HISTORIC AND DESIGN REVIEW COMMISSION

HDRC CASE NO: 2022-430
ADDRESS: 130 KING WILLIAM
LEGAL DESCRIPTION: NCB 737 BLK 2 LOT 7 & 8
ZONING: RM-4
CITY COUNCIL DIST.: 1
DISTRICT: King William Historic District
LANDMARK: Individual Landmark
APPLICANT: Marques White/Legacy Home Improvements
OWNER: SAN ANTONIO ART LEAGUE
TYPE OF WORK: Porch roof replacement with pitch change
APPLICATION RECEIVED: July 17, 2022
60-DAY REVIEW: Not applicable due to City Council Emergency Orders
CASE MANAGER: Jessica Anderson

The applicant requests a Certificate of Appropriateness for approval to replace the flat metal roof of the wraparound porch with a pitched standing-seam metal roof.

A2.1

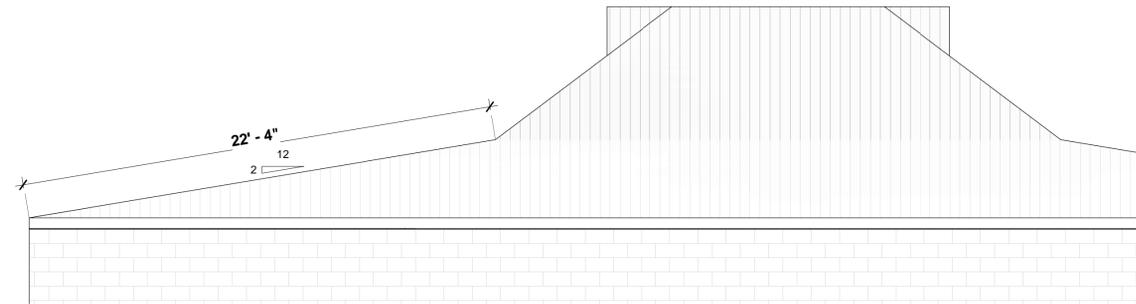
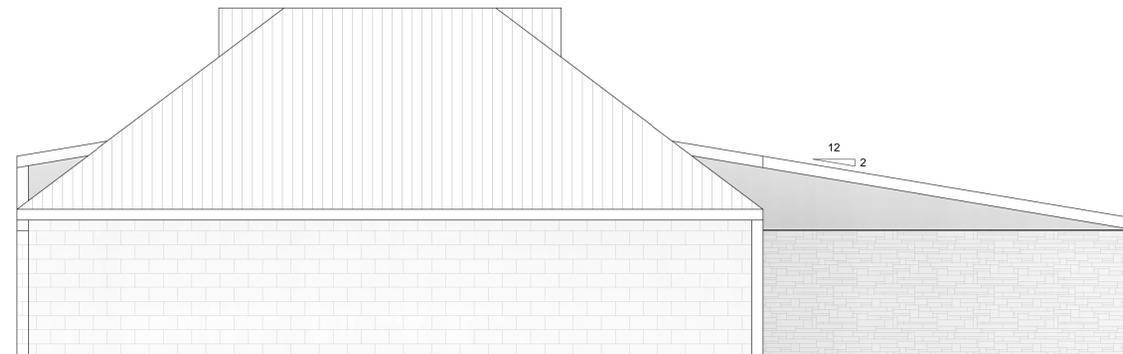
- b. ROOF: The primary roof form is a standing-seam metal Dutch hip roof with a flat roof on the porch that wraps around the northwest and southwest sides of the second floor. The applicant proposes removing the flat roof and installing a standing-seam metal roof with a 2/12 pitch. While installation of a standing seam metal roof conforms to Historic Design Guidelines, Guideline 3.B.ii states that the original shape, line, pitch, and overhang of historic roofs should be preserved when replacement is necessary. Staff finds the proposed change in roof pitch does not conform to guidelines.

- i. That the pitch of the roof remains unchanged when the new roof is installed or include a low enough profile as to not be visible from the public right-of-way.

To achieve our minimal pitch change across the 10' flat roof span, we will start our pitch decline from just 20" inches (less than 1 foot) above the current base which would obviously decline toward the eave from there. This minimal change would provide much needed positive drainage and peace of mind for the museum, while remaining completely invisible and non-noticeable from street level, with many feet to spare in that regard. This will undoubtedly meet the committee's requirement to include a low enough profile as to not be visible from the public right-of-way.
